Project Number: 3613	Rockland Plaza Winners - Addendum 01 (Q & A)	December 16, 2024
----------------------	--	-------------------

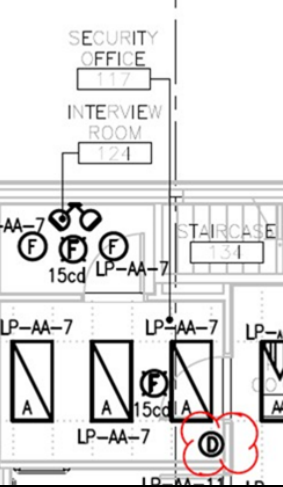
16	GWAL (ELECTR)	FACP. is it from top or bottom & how many?	Please see picture above. Given that the panel is recessed, we can not advise on incoming conduit. Once the wall is opened, and we can see where the feed is coming from and the electrical contractor will be in charge of assessing and providing all the necessary conduit / wire, relocating and feeding it from above or below, depending on what this current setup is.	16-Dec-24	ADD 1
17	GWAL (ELECTR)	Note # 61 is attached to Panel LP-B3 but the note# 61 detail missing, please provide.	Note 61 is in fact note 49. We will revise.	16-Dec-24	ADD 1
18	GWAL (MECH)	Please provide correct RTU numbers on new SLD & on Roof units.	Single line diagram will be revised to show the correct RTU names.	16-Dec-24	ADD 1
19	DCA	Are non-OIRCA roofers allowed to do this job?	Yes, Roofers can be non-OIRCA.	16-Dec-24	ADD 1
